Sheet: /fpga/adc/
File: adc.kicad_sch

Sheet: /power/		
File: power.kicad_sch		
Title:		
Size: A4	Date:	Rev:
KiCad E.D.A. 9.0.7		Id: 5/12

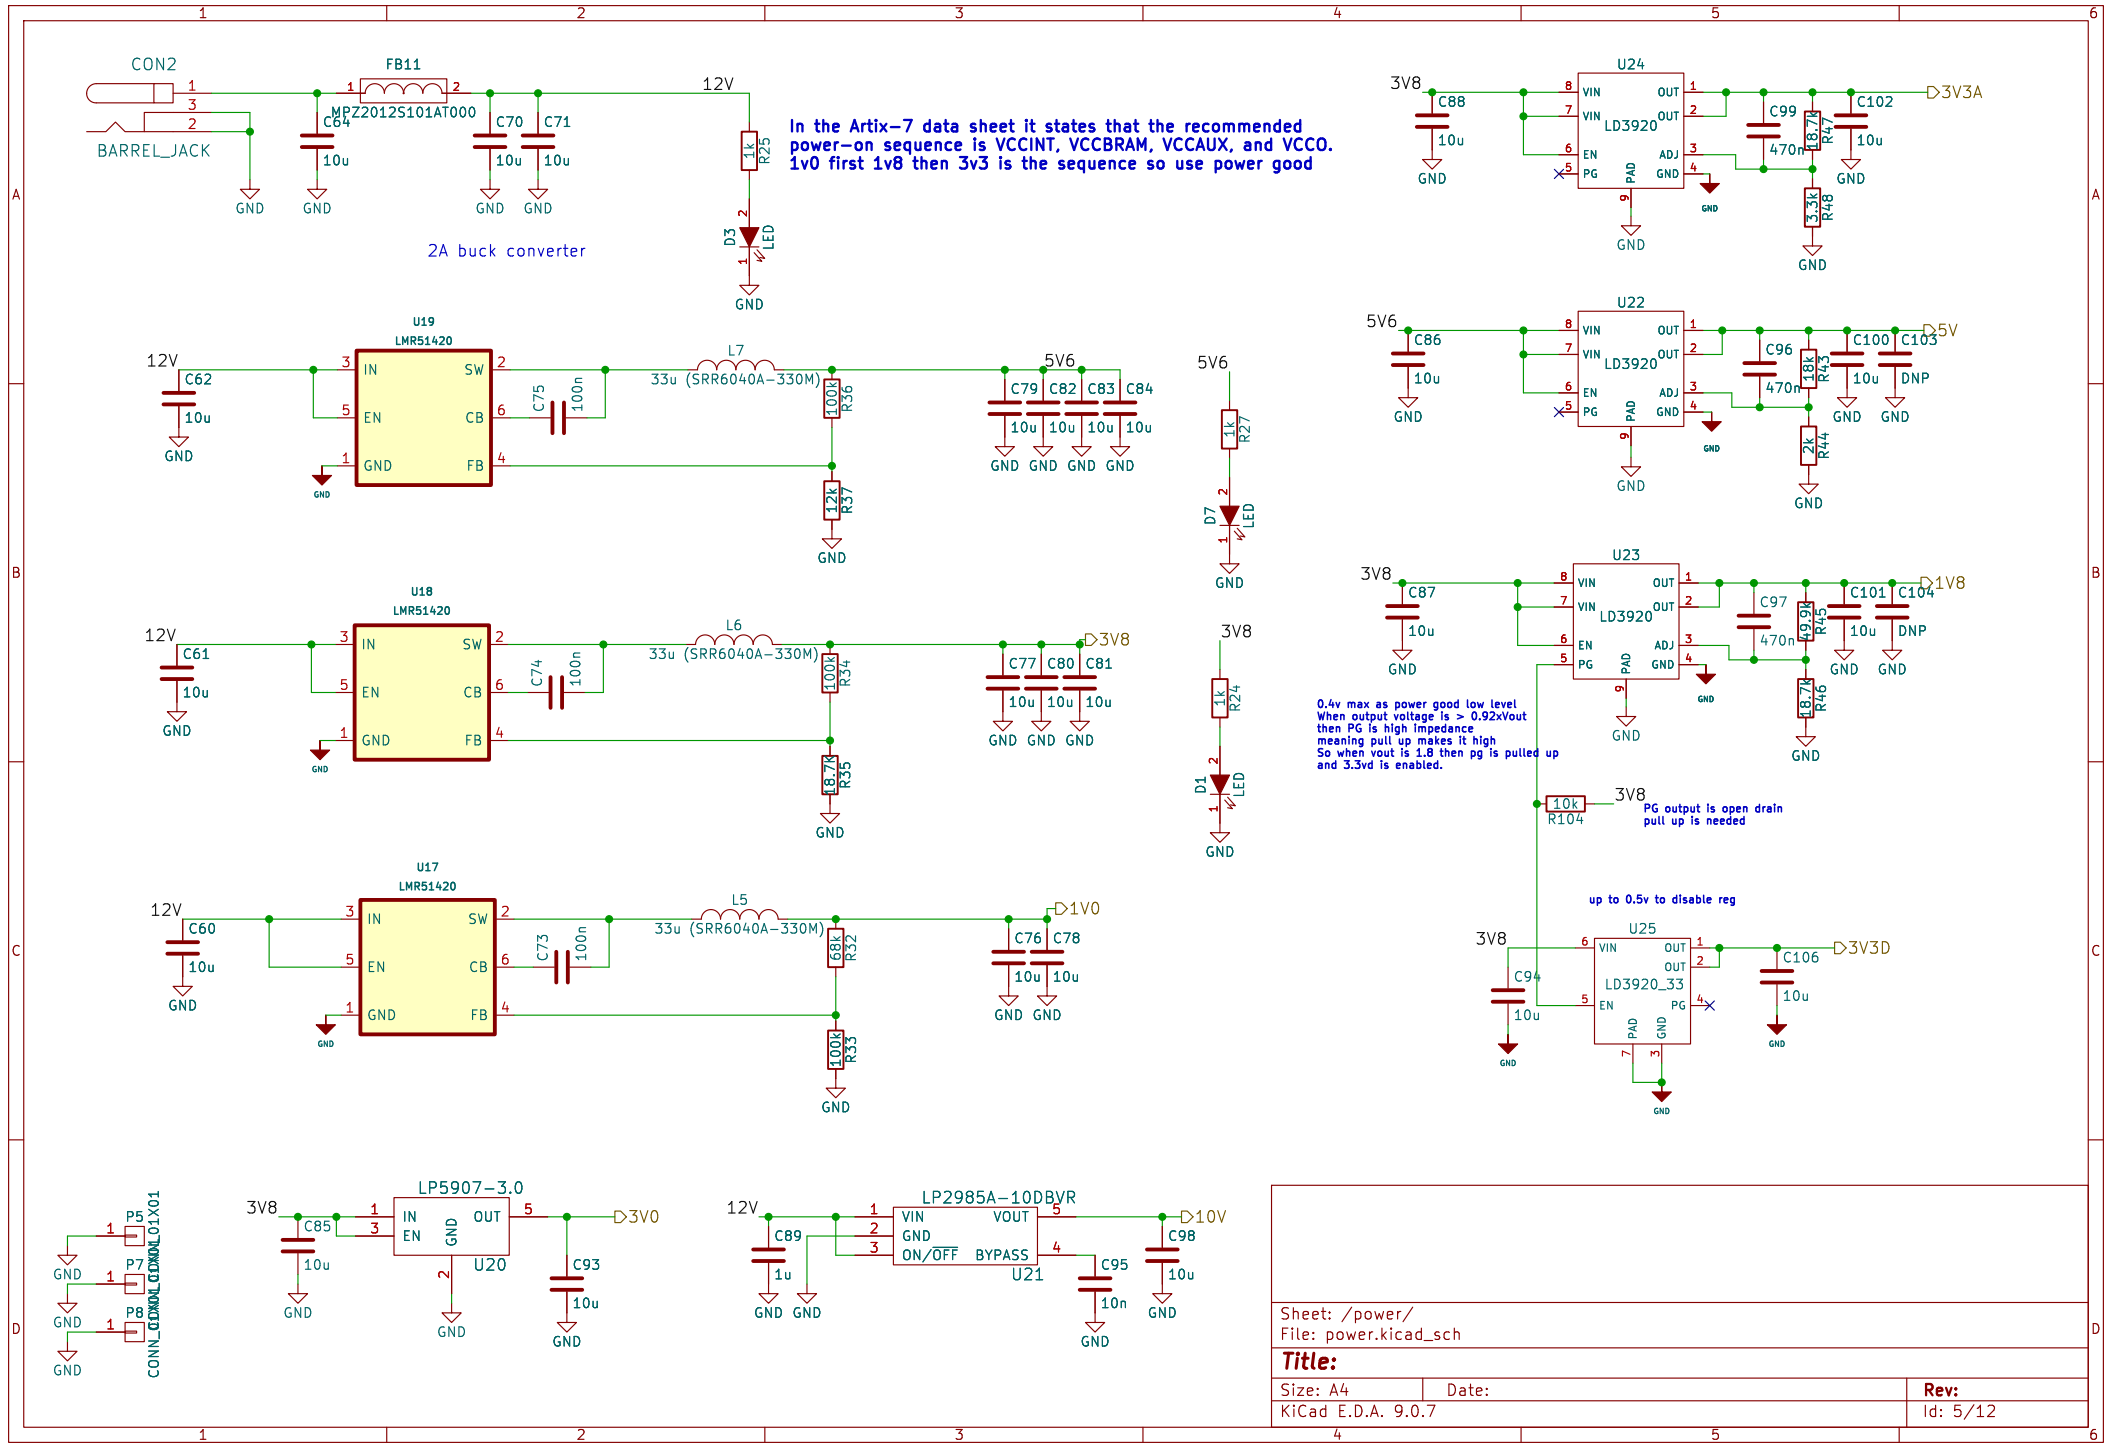
In the Artix-7 data sheet it states that the recommended power-on sequence is VCCINT, VCCBRAM, VCCAUX, and VCCO. 1v0 first 1v8 then 3v3 is the sequence so use power good

Id: 6/12

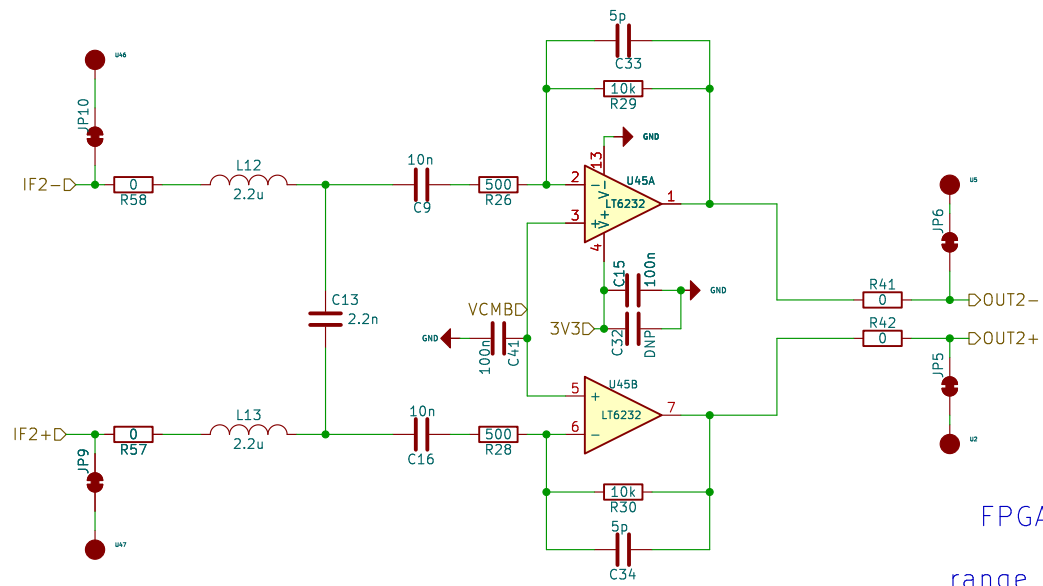
FPGA FIR Filter works perfectly.
Second stage for HPF
range compensation filter is removed

Sheet: /opamp_amp/
File: opamp_amp.kicad_sch

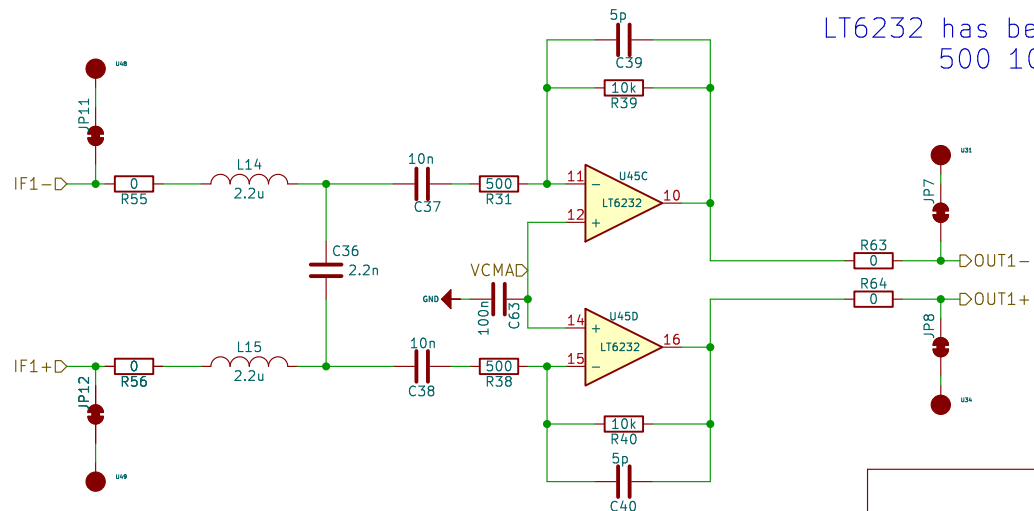
LT6232 has better noise performance as $1.1\text{nV}/\sqrt{\text{Hz}}$
500 10K has less noise contribution

Sheet: /rx1/ File: rx.kicad_sch		
Title:		
Size: A4	Date:	Rev:
KiCad E.D.A. 9.0.7	Id: 9/12

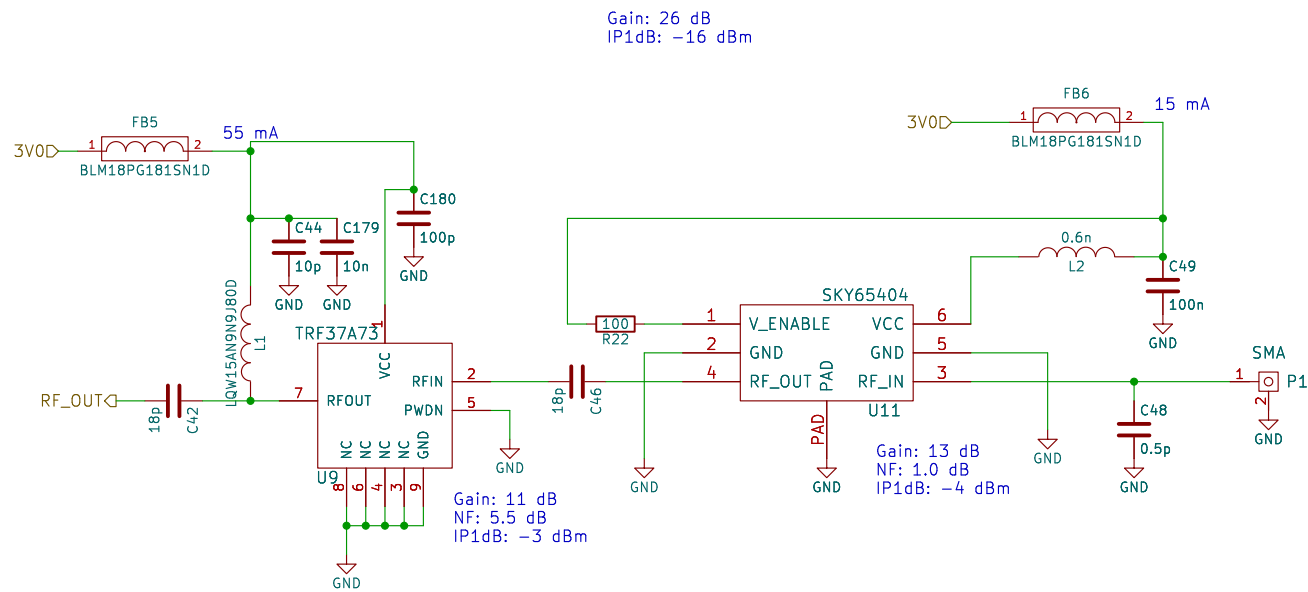
3.0V current: 70mA

Sheet: /clock/
File: clock.kicad_sch

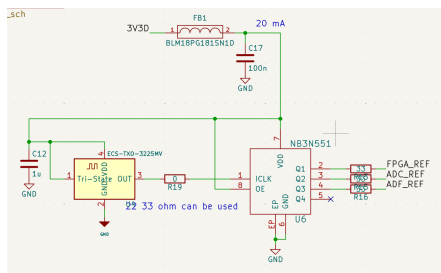
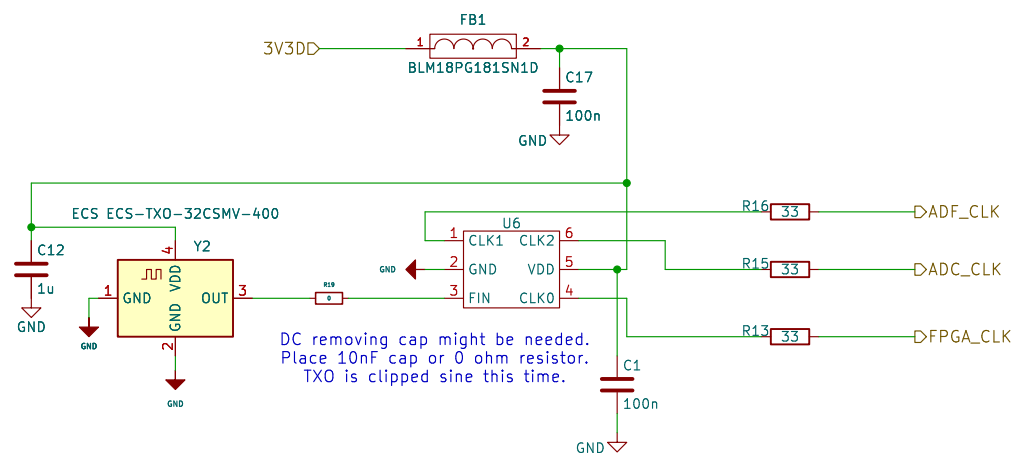
This is the prev design:
NB3N551 is obs.
Also this txo is generating pure sin.
ADC might need cmos like input not sin.
That could be the reason of duty stabilizer.
